[Docket No. FAA-2024-0237; Project Identifier AD-2023-00491-R; Amendment 39-22853; AD 2024-19-11]

#### Airworthiness Directives; Robinson Helicopter Company Helicopters

Final rule.

Figure 1 to Paragraph (g)(1)(i)—Flex Plate Inspection

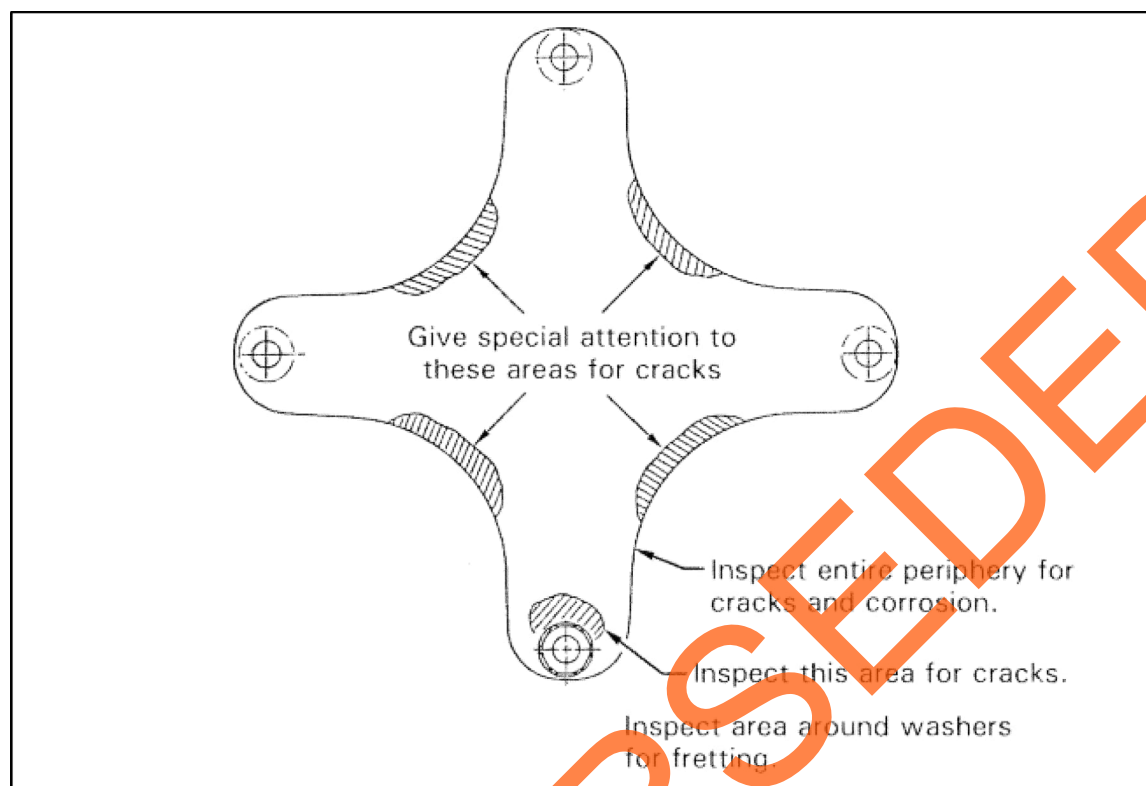
(i) Visually inspect forward flex plate assembly (flex plate) part number (P/N) C947-1 for any loose fasteners, cracks, fretting, corrosion, wear, and to ensure that the washers are bonded to both sides of each flex plate arm, in the areas depicted in Figure 1 to paragraph (g)(1)(i) of this AD. If there is any loose fastener (can be moved by hand), crack, fretting, corrosion, or wear that consists of the

washers not securely bonded to both sides of each flex plate arm, before further flight, remove the flex plate from service and replace with an airworthy flex plate.
